GE Medical Systems

This is in response to your July 18, 2000 request for additional information on our Model V-TransACT application.

Find in the following document my answer to the question related to the V-TransAct NRC submission.

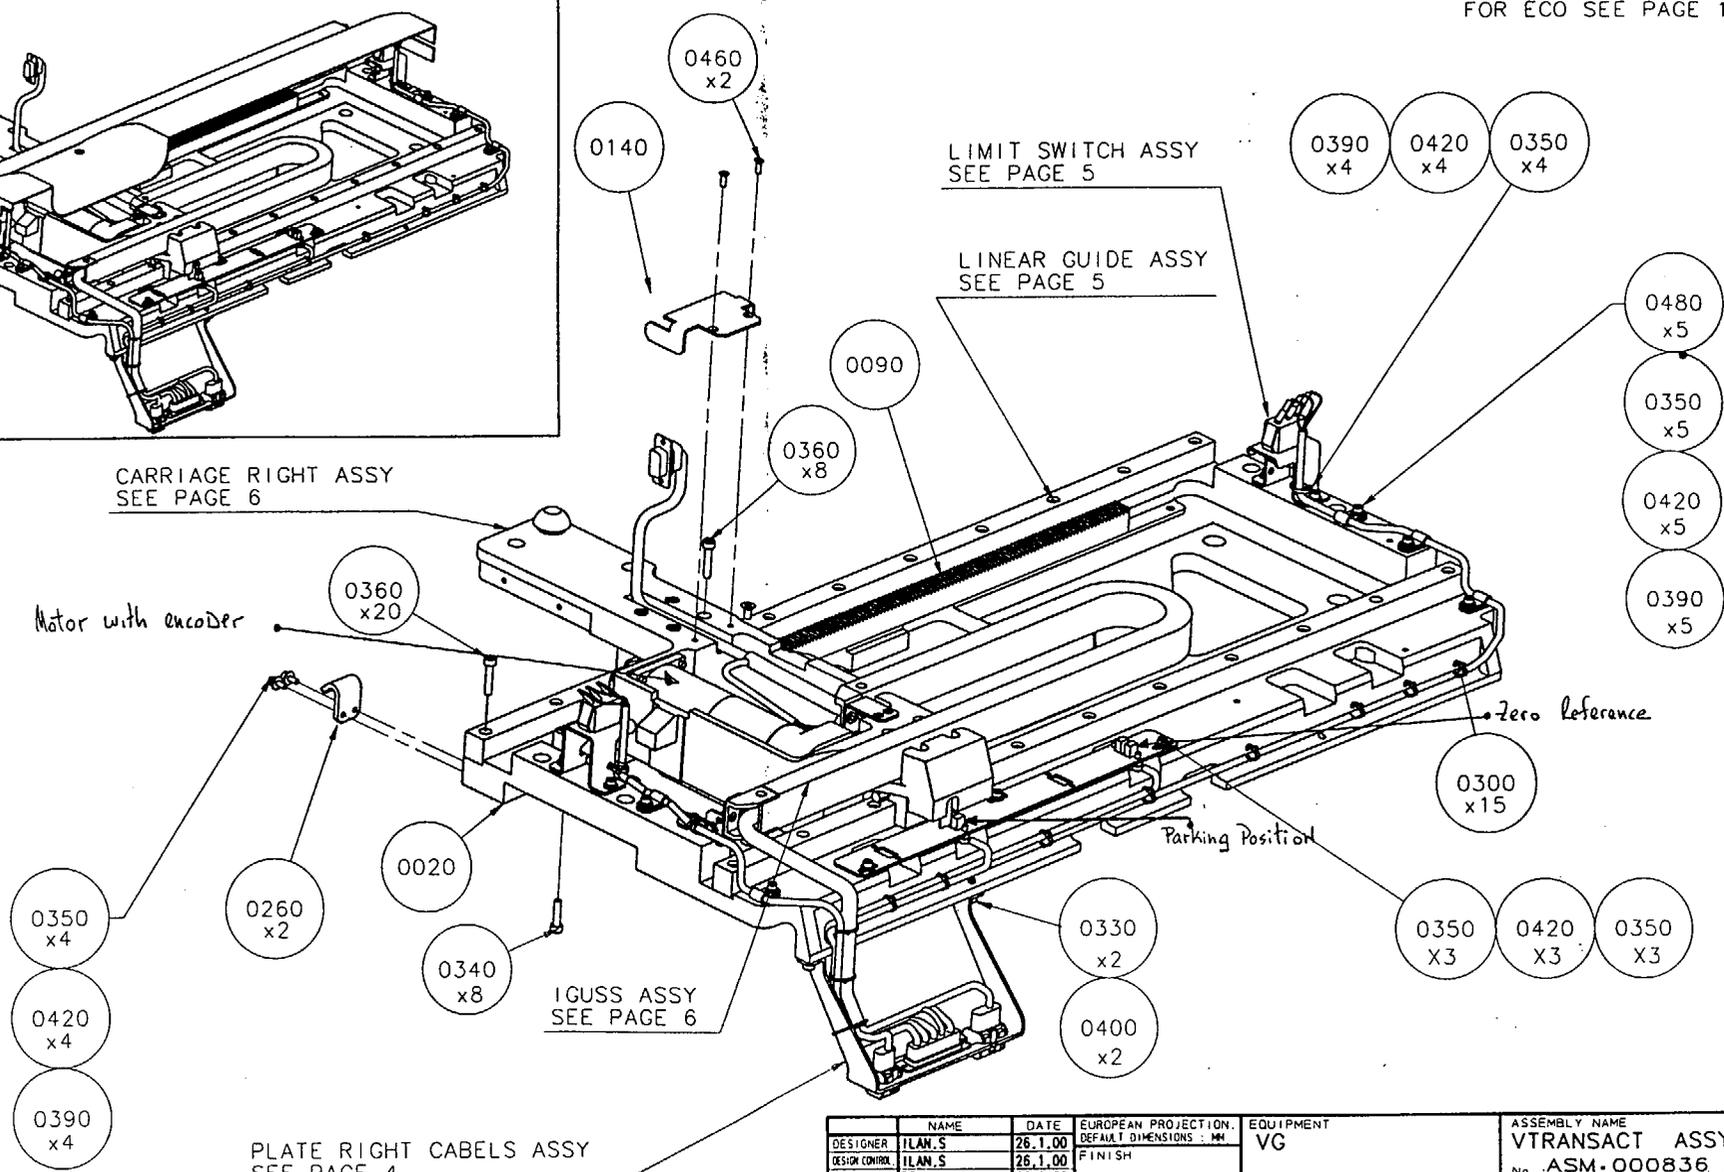
2. **Page 1-11:** Find in appendix A.2 the corrected page.
3. **Other devices:** There is no other device attached to the gantryh
4. **Sensing switches:** There are two devices that give information on the position of the rod unit: the zero optocoupler and the encoder on the motor that moves the rod.
The zero optocoupler is a reference point that permits the reset of the rod position each time the rod reach this point. This reduces eventual error in the rod position information. The encoder on the motor gives the information on the rod position respectively to the zero position.
Another device that permit adequate mechanical function of the motion mechanism is the limit switches. See drawing number ASM 000 792, appendix A.3.

A.7

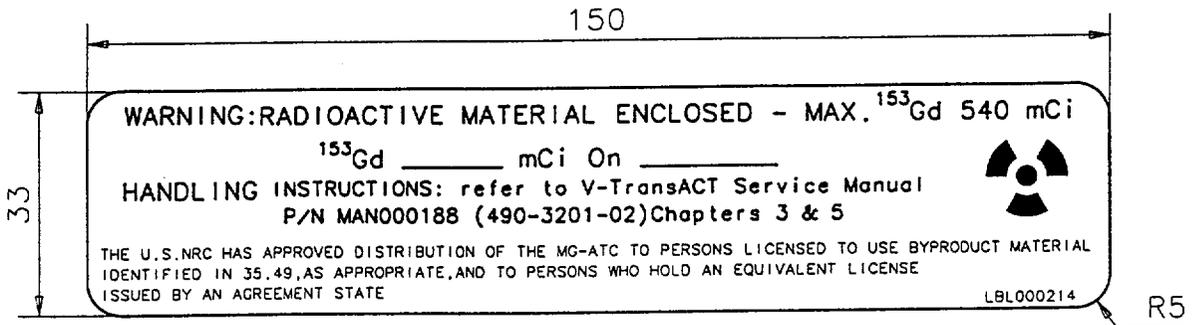
11. It will be take in consideration.
12. **User:** The devices will only be distributed to users licensed to 10 CFR 35.11 or equivalent Agreement State regulations.
13. **CFR:** See the updated page 2-13 of the Operation and Service Manual according to your remarks on the CFR. We replaced all the sections by section 10 CFR 35.49. The other section 10 CRF 35.500 is related to therapy device and not attenuation correction device, see updated label in appendix A.7, A.8 and A.9.
